TECH-NIQUE

S-235

SUBJECT: BL-100 - (EARLY PRODUCTION UNITS)

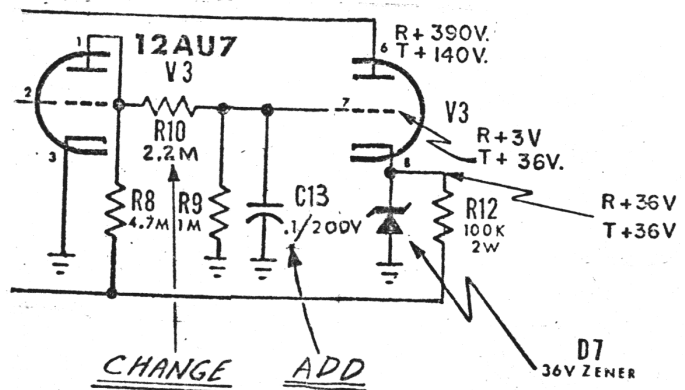
Under certain conditions when used with SSB Transmission, relay chattering can occur. To alleviate this condition the following changes can be made:

1. Add Diode D8 (Part #RE7) across relay K1.
2. Add capacitor C13, .1MFD, 200VDC (Part #CM57) from the grid, pin #7 of V3 (12Au7) to ground.
3. Change the value of resistor R10, 1meg. ohm to 2.2meg. ohm (Part #RC225-2).
